25-27 LEEDS STREET, RHODES | SSD-67419241

Amendment Report

Prepared for
BILLBERGIA
30 June 2025

Figure 3 Proposed seawall works

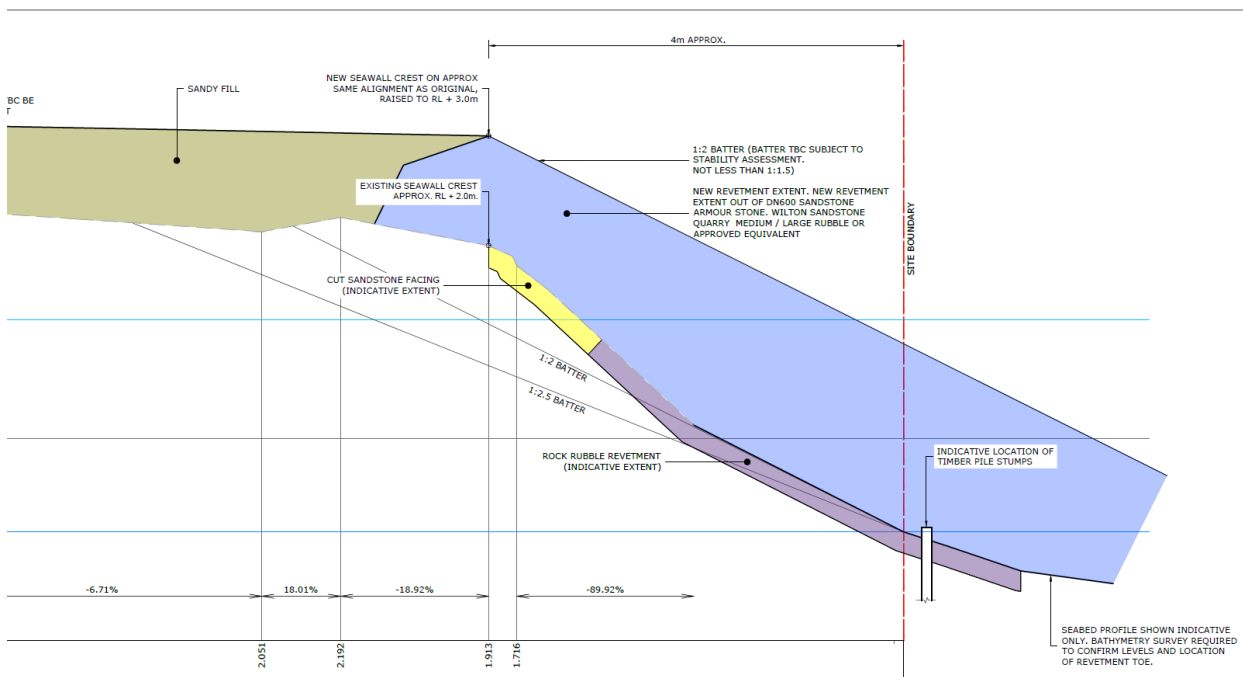
The proposed arrangement shown on the plans in Appendix O involve a rock rubble revetment up to a raised crest level of +3.0mAHD. The crest of the seawall has been maintained on the current alignment, which results in the toe of the batter extending further seaward than the current revetment and beyond the existing property boundary. Maintaining the current alignment was selected to maintain the current area of public space behind the seawall.

In order to add stability and height to the existing revetment seawall for the new loads and levels, Tonkin proposes to add mass in the form of additional armour stone on a 1:2 batter slope. This may involve a large

The existing timber pile stumps are proposed to be retained as they offer benefits to the seawall stability and retention would minimise disturbance.

Figure 5 Updated Tree Management Plan

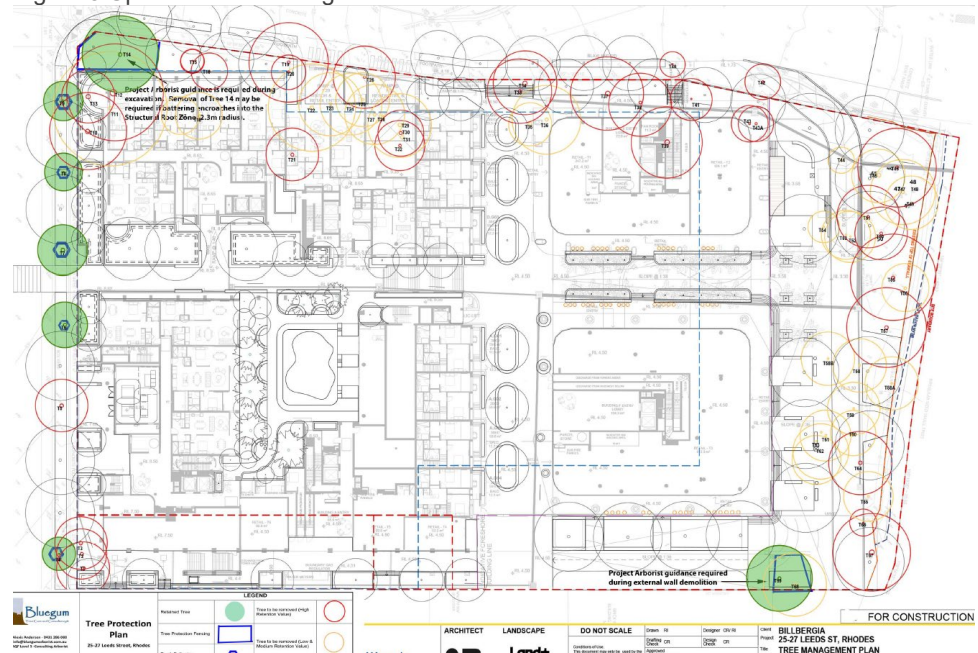
The proposed raising of the seawall which requires additional fill has resulted in a raised ground plane and the proposed removal of additional existing trees along the foreshore, based on arborist advice regarding the impact of the raised levels on these trees.

The proposed tree removal will be offset by 150 replacement plantings. This strategy will ensure:
